APLIN & MARTIN CONSULTANTS LTD 101 - 38650 Old Yale Road, Abbotsford, B. C. V2S 2J5 Tel: (778) 880-0077, Fax: (778) 880-0078, E-mail: general@aplinmartin.com	CLIENT: SYCAMORE DEVELOPMENTS LTD.		DRAWING NO.
	PROJECT: 21-UNIT TOWNHOUSE DEVELOPING - 5633 TESKEY WAY		26182 - 06
	SITE SERVICING PLAN		OF 06 OF 08 ISSUE/REVISION 7

Riparian Areas Regulation - Qualified Environmental Professional - Assessment Report

QEP Assessment # (633) – 5635 Teskey Way (LOT 2 EXCEPT PART DEDICATED ROAD ON PLAN LMP15965 AND BCP30311, SECTIONS 5 AND 8 TOWNSHIP 26 NEW WESTMINSTER DISTRICT PLAN EPP45)

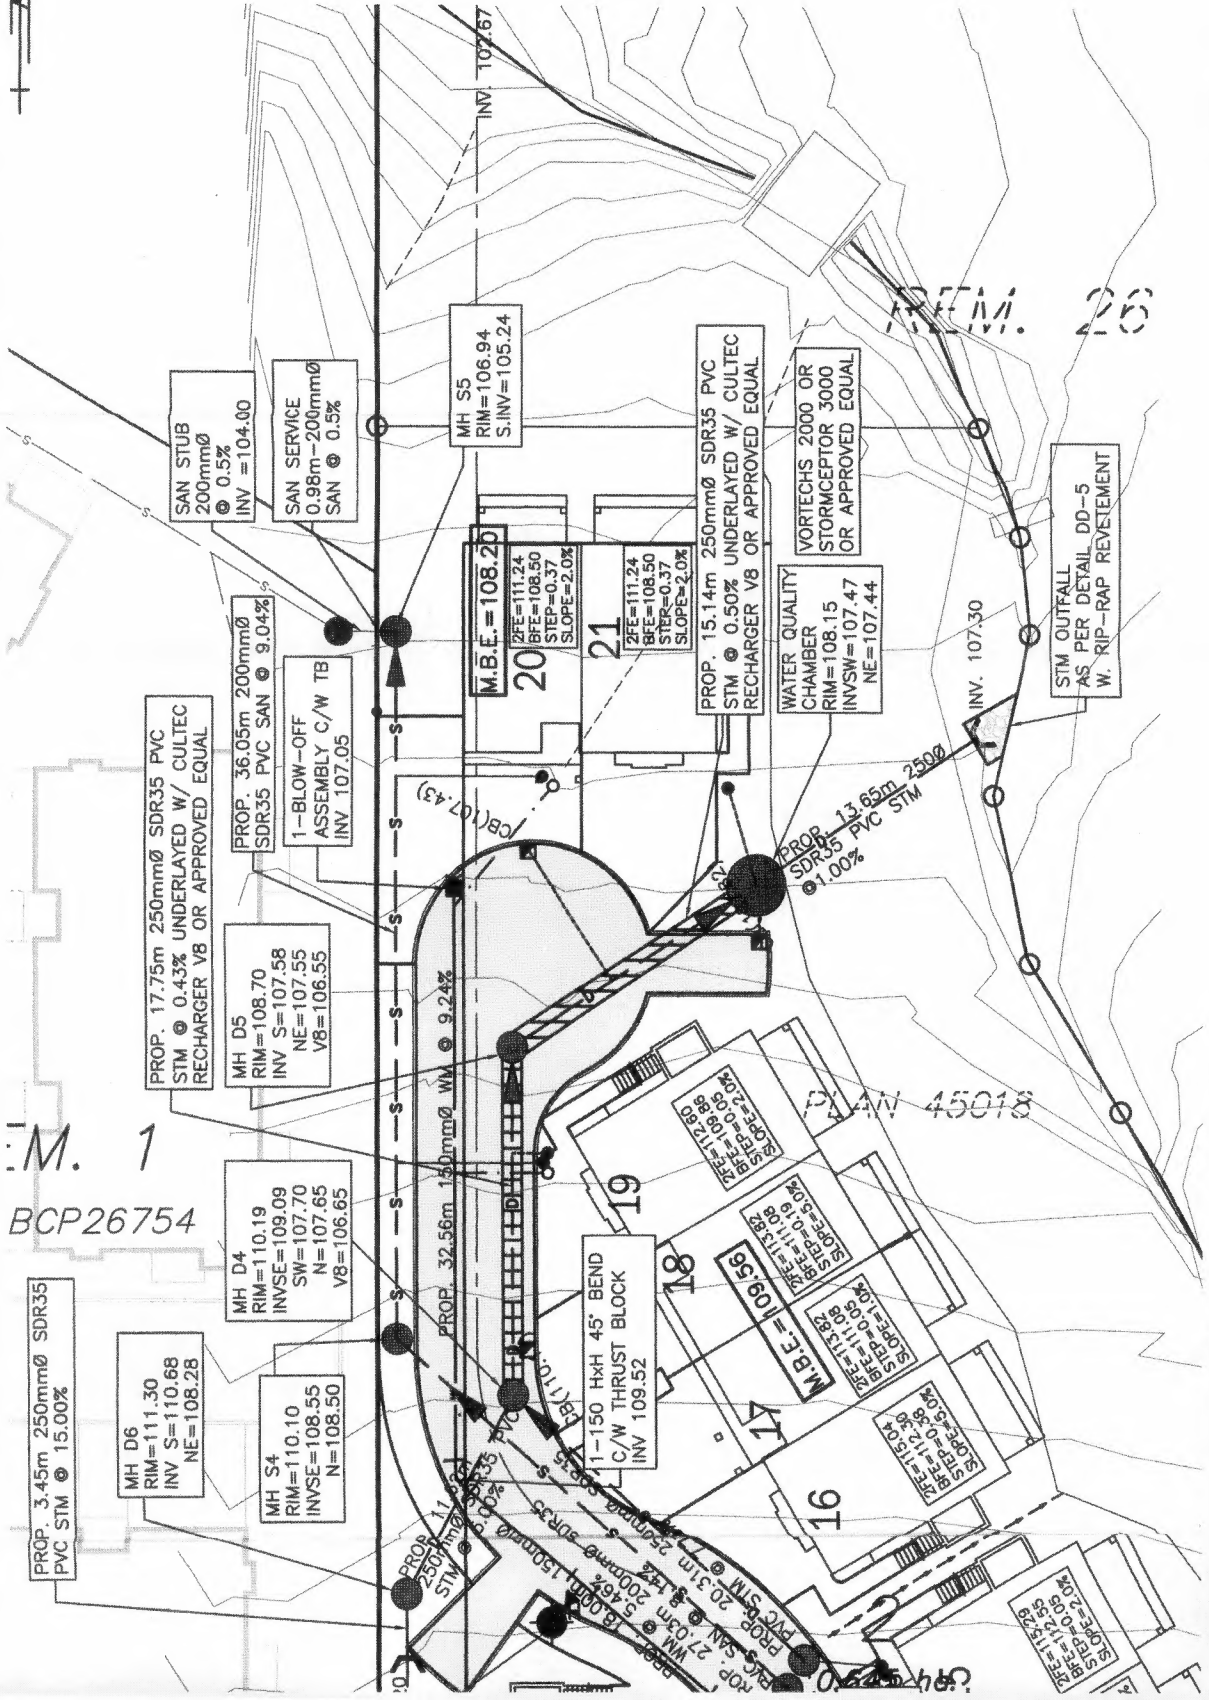
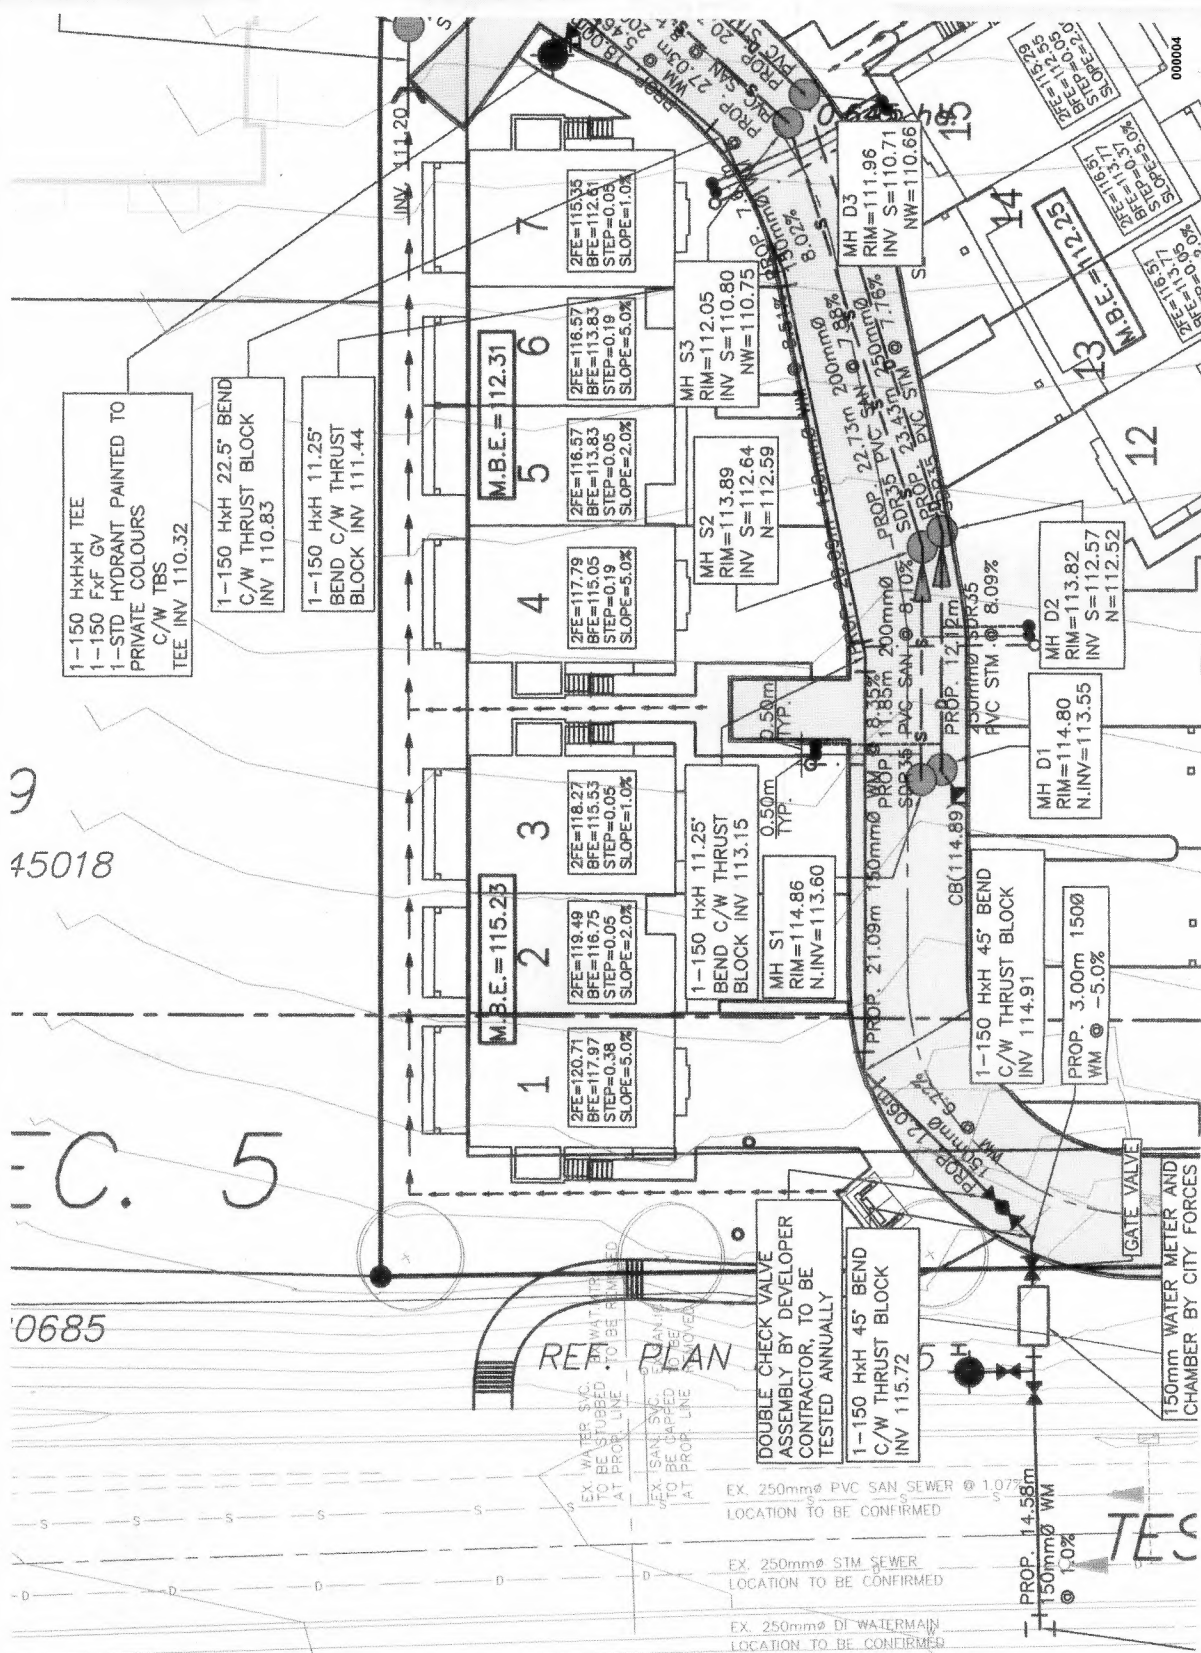
- need a fence. to protect SPEA P. 12 of 17
- any large trees removed in outfall area
- height of outfall to creek??
→ how does that work
- tree replacement per guidelines for hazards.
- why ~~stream~~ → road & infiltration both going to treatment chamber.

Section 3. Site Plan

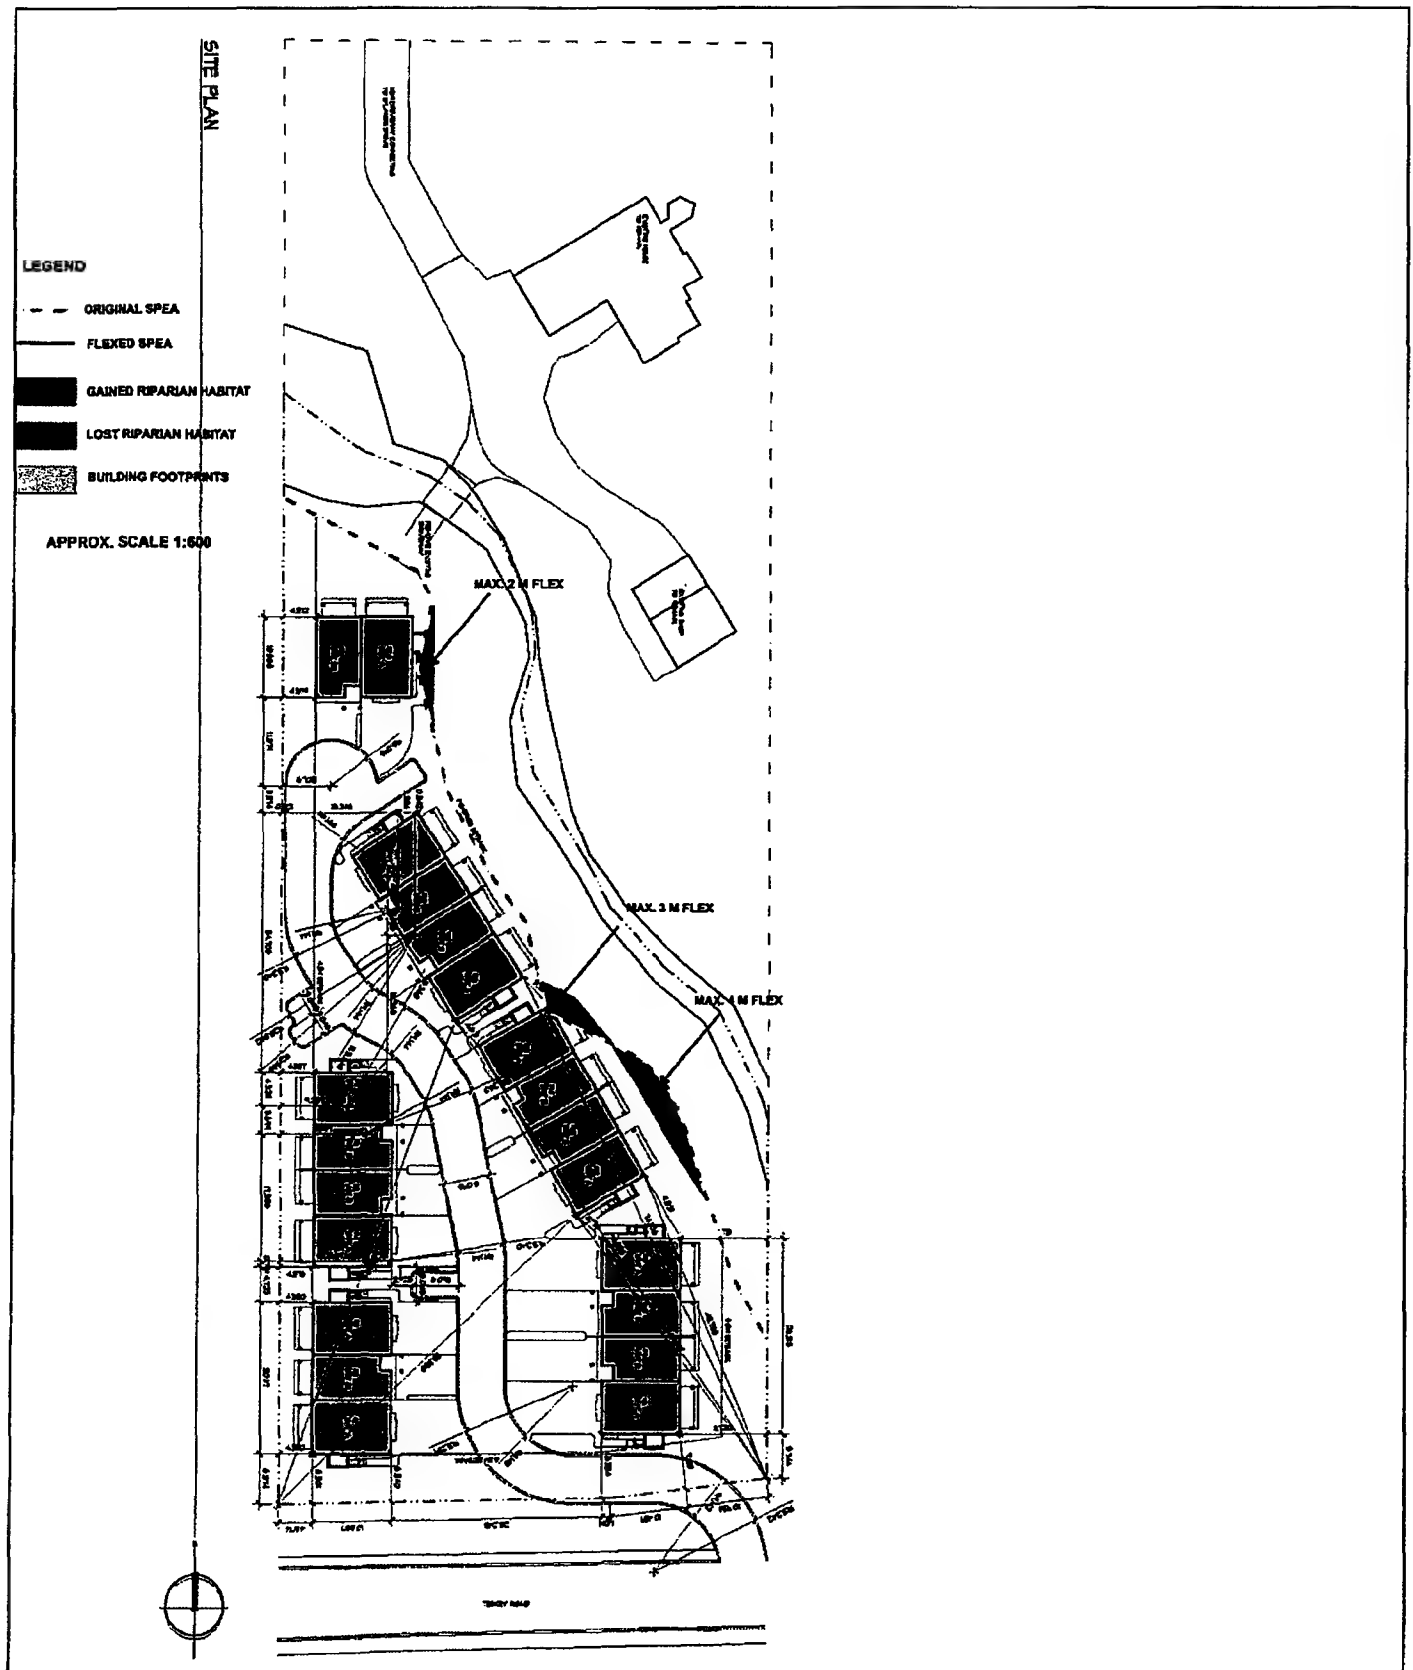
This assessment is a modification of the original assessment completed by Jacques Whitford AXYS Ltd. (JWA). During the course of construction, two (2) locations on the subject property where the building footprints encroach into the SPEA as determined in the original report were identified; the first at the north end of the lot at the east side of the two units located there – a small side deck encroaches into the SPEA, and in the centre of the lot, at the north end of the block of homes where the corner of the block encroaches into the SPEA.

After reviewing the building plans and the original report, it is my opinion that a small "flexing" of the SPEA to a maximum of four (4) metres is sufficient and appropriate to deal with the encroachment. An updated site plan has been included in this report and follows the original SPEA assessed by JWA.
